SUBARU®

NUMBER 15-87-91

SERVICE BULLETIN

SUBJECT: EVAPORATOR CASE MODIFICATION FOR INSTALLATION

ZEXEL

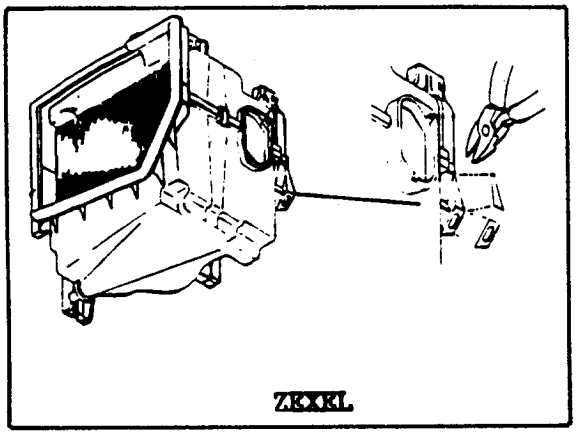
Due to a design change of the blower housing a tab must be removed from some evaporator cases prior to the installation of either Zexel (Diesel Kiki) Kit P/N G3010AA010 and Calsonic Kit P/N G3010AA000.

Failure to remove this tab will result in difficulty when installing the evaporator case to the blower housing. The tab will also affect the seating between the two cases, resulting in an air gap.

Using snips, wire cutters, or suitable device, cut only the indicated portion of the tab away from evaporator case.

When installing the evaporator assembly, be sure no remaining evaporator case material interferes with the blower case and no air leaks exist.
